New Air Traffic Control Tower at Indianapolis Airport
Report In Response to RTI 31402
December 14, 2001

ROC Engineering received RTI 31402 on Dec 8, 2001. The Indianapolis Weather Forecast Office (WFO) contacted the NEXRAD Hotline in Norman, Oklahoma requesting analysis of a new Air Traffic Control Tower (ATCT) being built at the Indianapolis Airport. The new ATCT is expected to be about 9000 feet from the WSR-88D and at least 280 feet tall.

Figure 1 – Side and Aerial diagrams of WSR-88D and ATCT

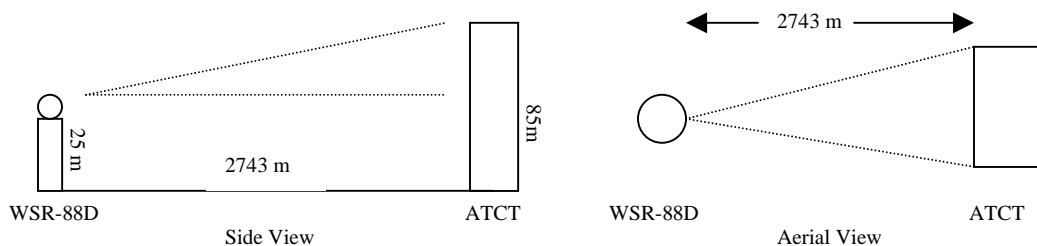
Assuming the base of the WSR-88D and ATCT are at the same elevation and given the above characteristics for each, the ATCT will extend at least 56 meters above the feed horn of the WSR-88D. At a range of 2743 m, the center of the WSR-88D beam will be above the ATCT at 1.16° of elevation (see figure 1 side view).

No data was provided regarding the width of the ATCT. For this analysis it will be assumed that the ATCT will be a rectangular tower 15 m (50 ft) across at the base. For this width, the tower will subtend $.313^\circ$ of the WSR-88D beam's azimuth (see figure 1 aerial view).

The lowest scan of the WSR-88D is 0.5° . When the WSR-88D is collecting data at this elevation angle, the main beam of the WSR-88D antenna will be blocked (in elevation) to $.66^\circ$ of the antenna bore sight. The ATCT will therefore introduce a total beam blockage bias of -2.26 dB. This beam blockage bias will decrease as the WSR-88D increases its scan elevation. The beam blockage bias is directly inserted into reflectivity and velocity measurements and will decrease their accuracy. In the case of precipitation estimates,
